REMEDIATION SYSTEM EVALUATION

DELPHI CORPORATION  
VANDALIA, OHIO

Report of the Remediation System Evaluation,  
Site Visit Conducted at the Delphi Corporation, Vandalia, Ohio Facility  
March 6, 2003

**Remediation System Evaluation  
Delphi Corporation  
Vandalia, Ohio**

**FIGURE 1-3. TCE DISTRIBUTION IN THE TOP OF ROCK**

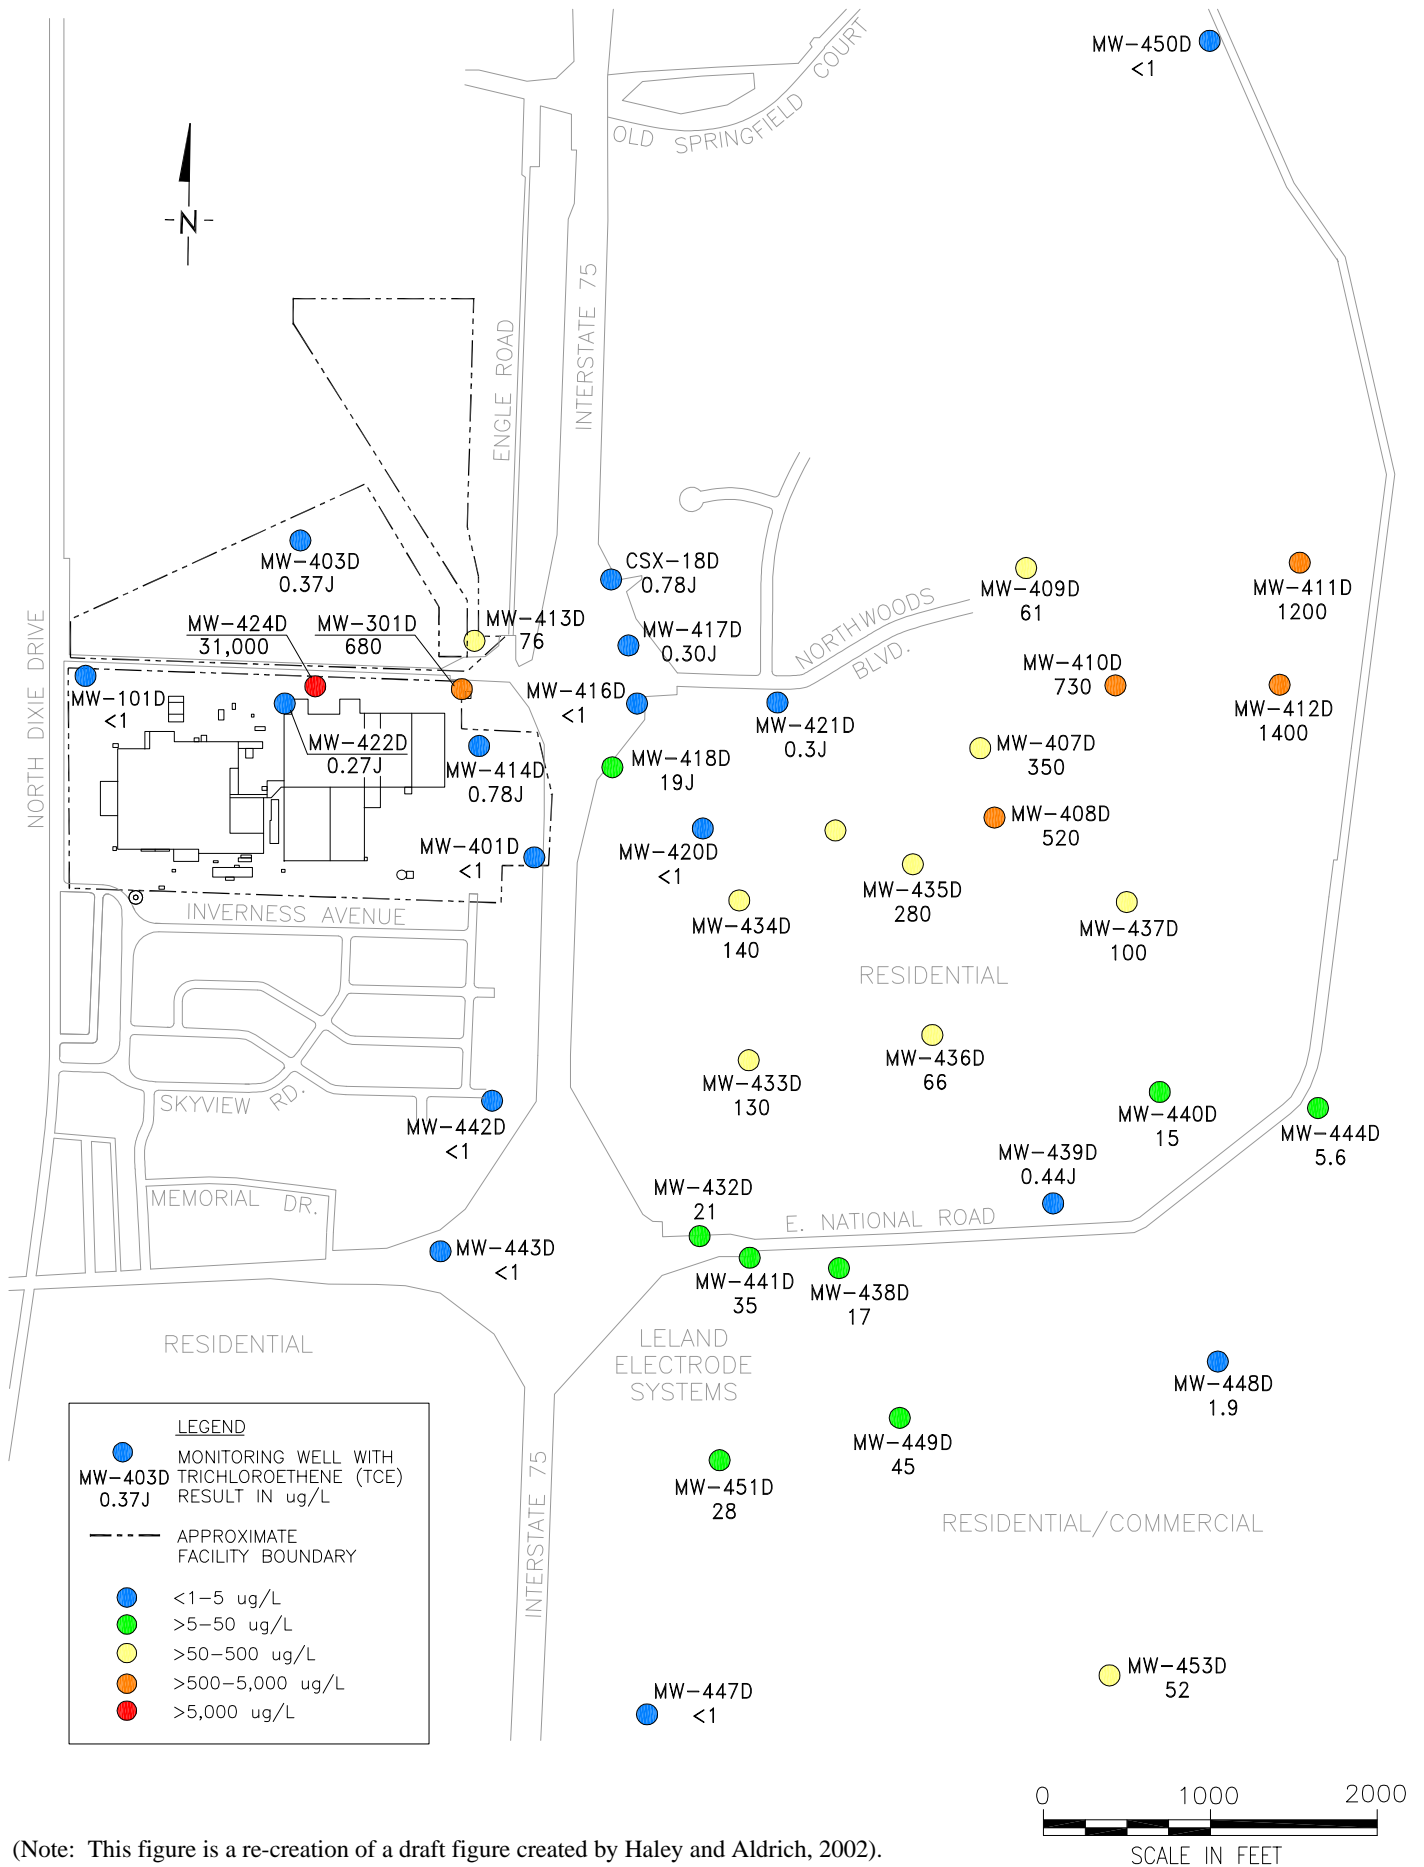
Dissolved ground water contamination in the Top of Rock zone (see Figure 1-3) appears to be controlled by a piezometric low near MW-424S (see Section 4.2.1 and 4.2.2 of this report) where water in the Top of Rock appears to discharge to the underlying Sugar Rock. Wells upgradient of this area historically have elevated TCE concentrations. For example, in the fourth quarter of 2002, MW-422S had a TCE concentration of 200,000 ug/L. Wells downgradient of this area (MW-423S, MW-445S, MW-446S, and others) have undetectable TCE concentrations. Although this piezometric low appears to capture site-related contamination within the Top of Rock aquifer, one supply well at a property located on Engle Road, located just north of the facility, has detectable concentrations of TCE that are below the MCLs. However, that well on Engle Road has an open intake that extends from the Top of Rock to the Sugar Rock, so the contamination at that well is likely drawn from the Sugar Rock.

In the Top of Rock, there is no intended target capture zone and no implemented remedy because contaminated water appears to be naturally contained by the discharge of water to the underlying Sugar Rock. As shown in Figure 1-3, ground water sampling and analysis in the Top of Rock suggests that VOC contamination above MCLs is limited to four wells in the north central portion of the property (MW-422S, MW-424S, MW-425S, and MW-428S). The sampling results from other monitoring wells in the Top of Rock and interpretation of capture from the potentiometric surface map suggest that the contamination in these wells is contained horizontally. The only indications of potential TCE or cis-1,2-DCE contamination in the Top of Rock that is likely outside of the capture zone are the sampling results from 10591 Engle Road, which is approximately 500 feet to the northeast of the facility and near the Unnamed Tributary. The concentrations at this location are below MCLs and all other wells in the area (both monitoring and supply wells) have no detectable concentrations of these constituents. This well is constructed with an open interval that extends from the Top of Rock to the Sugar Rock and it is likely that TCE in this well is related to the Sugar Rock.

FIGURE 1-4. TCE DISTRIBUTION IN THE SUGAR ROCK, FIRST QUARTER 2003

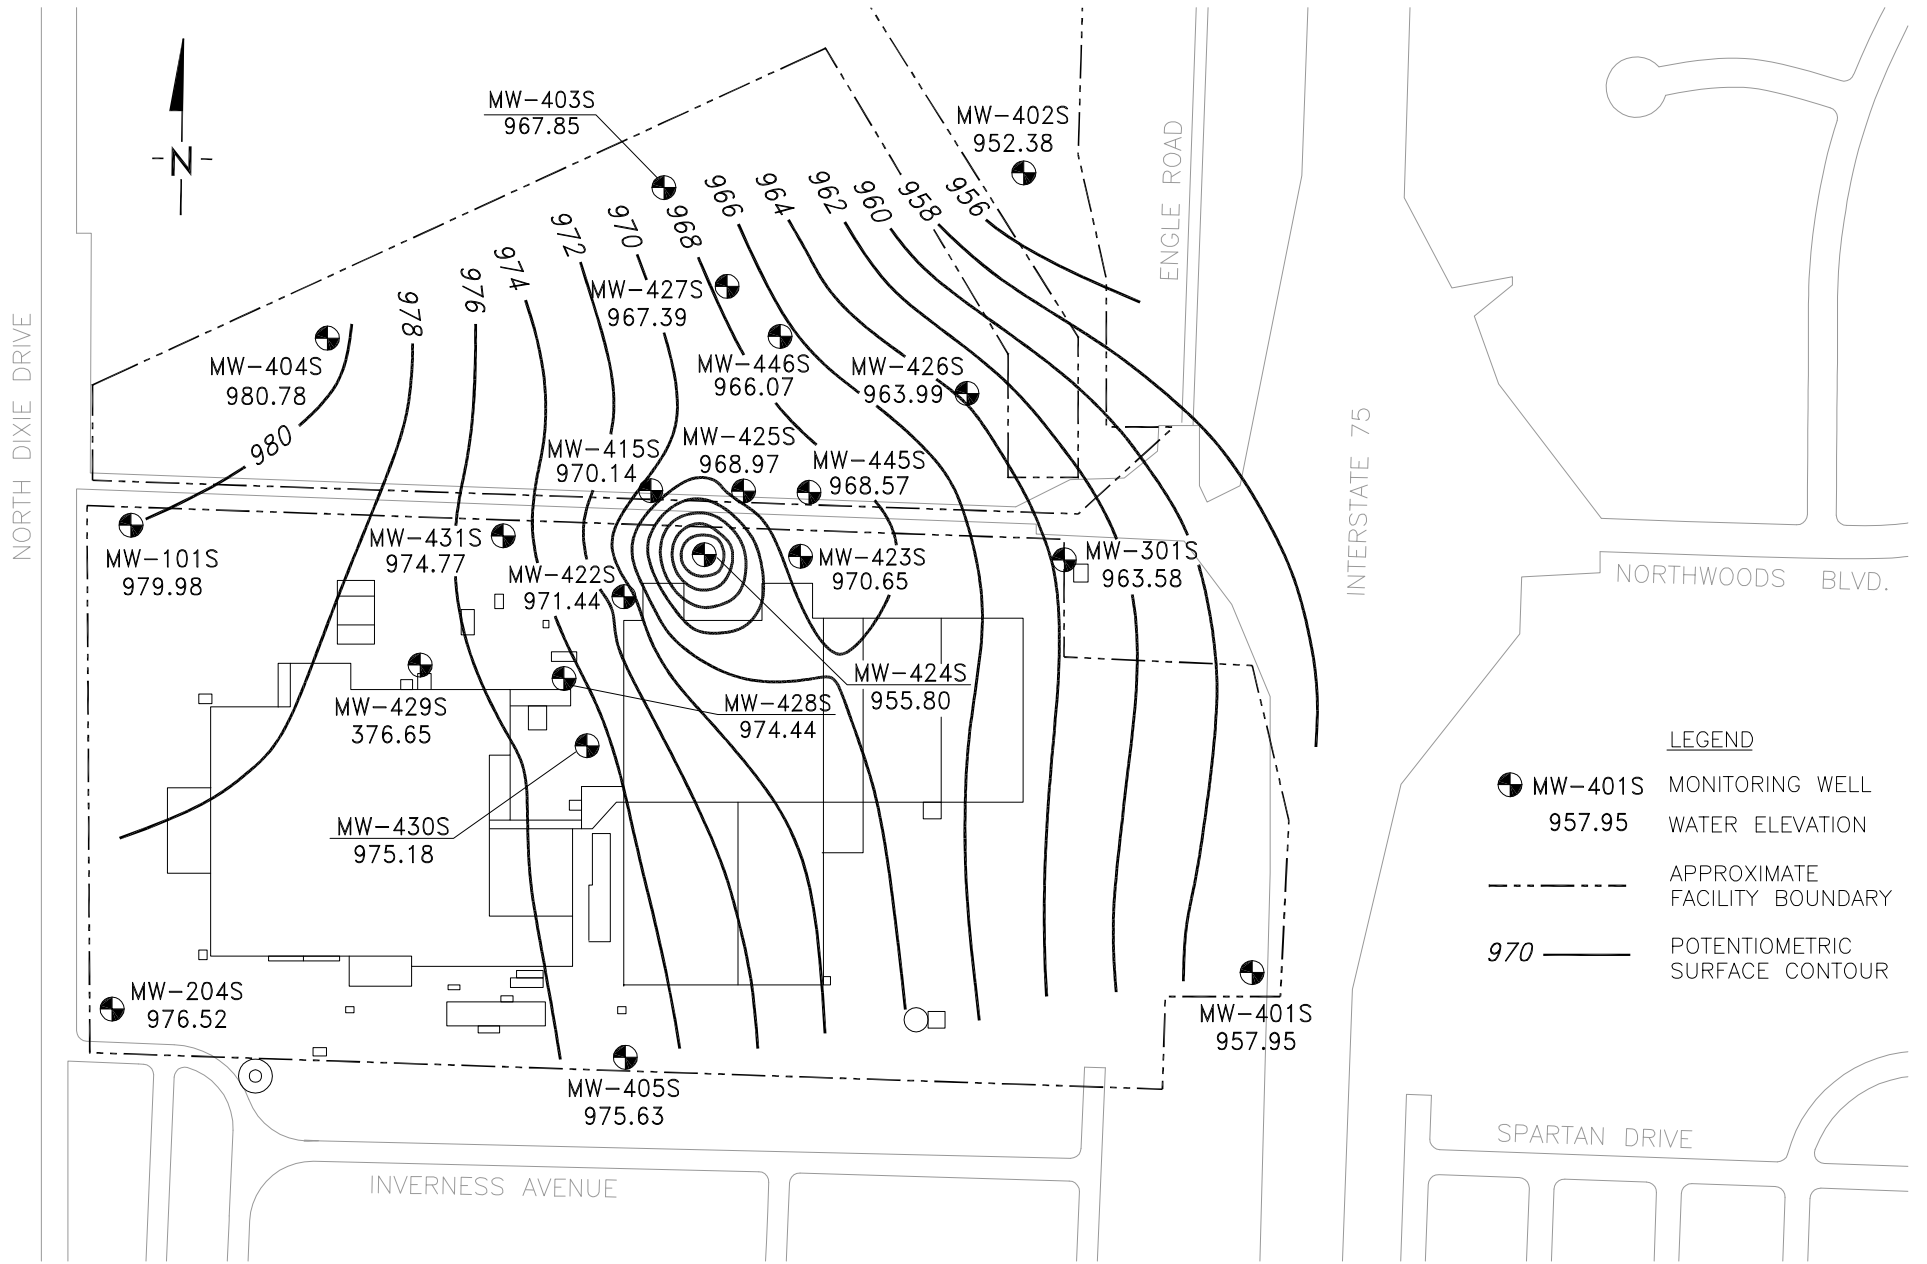
Ground water contamination in the Sugar Rock extends over a mile from the site to the east. The highest concentration in this unit is repeatedly detected at MW-424D (see Figure 1-4 for location), which is located in the area where TCE impacted water from the Top of Rock zone is suspected to enter the Sugar Rock through an old production well boring. During the fourth quarter of 2002, MW-424D had a TCE concentration of 30,000 ug/L. Elevated concentrations of cis-1,2-DCE and 1,1 DCA were also detected (5,000 ug/L cis-1,2-DCE and 290 ug/L 1,1 DCA). Concentrations offsite to the east decrease near P-301, which is the extraction well for the ground water migration control system, and then increase again approximately 3,000 feet from the facility. In the first quarter of 2003, the TCE concentrations along Cassel Road were over 1,000 ug/L (1,200 ug/L in MW-411D and 1,400 ug/L in MW-412D). Beyond these points ground water discharge through seeps to surface water that eventually empties into the Great Miami River.
